Work Order ID 114420

Item Name: Clamp Half, Attachment

SHOP COPY
RETURN TO
ENGINEERING
UNCONTROLLED COPY
WITHOUT NOTICE
WORK ORDER
NO. 114420 MP
14-03-05

D4079-1 CLAMP HALF, ATTACHMENT

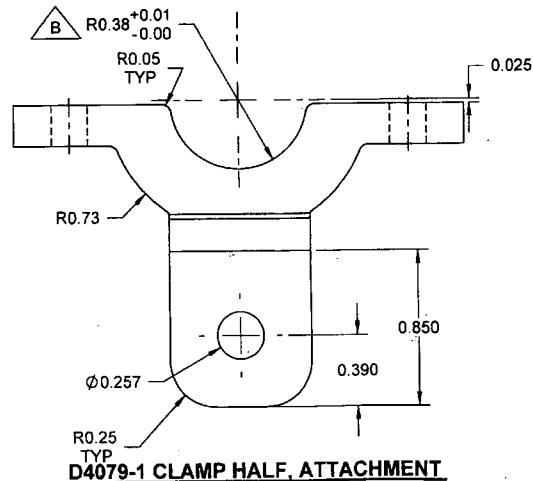
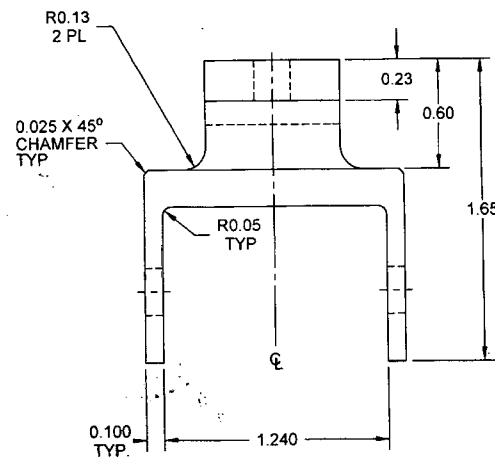
| Root Cause | Date | Step | Qty | Description of work order update or non-conformance | Initial Chief Eng | Action Description | Sign & Date | Verification | QC Inspector |
|---------------|--------------|------|-----|--|-------------------|---|---------------------------------------|------------------|---------------|
| Equip/Tooling | X 2014-03-23 | 110 | 3x | tolerance .230 is taper #1 .227 - .215 (Good) #2 .222 - .215 (Good) #3 .218 - .130 (Scrap) Rc. Jaws on use not correct. <u>\$9.44</u> | A.P. 14.03.24 | REWORK JIGS (JAWS) DIM FOR THICKNESS IS 0.23 ± 0.030". THICKNESS IS O.K. TAPER ON PART IS ACCEPTABLE AS LONG AS MINIMUM THICKNESS OF 0.840" IS MAINTAINED. | JFC 2014-03-23 A.P. 14.03.24 | A.P. 14/03/24 | S 14/03/24 |
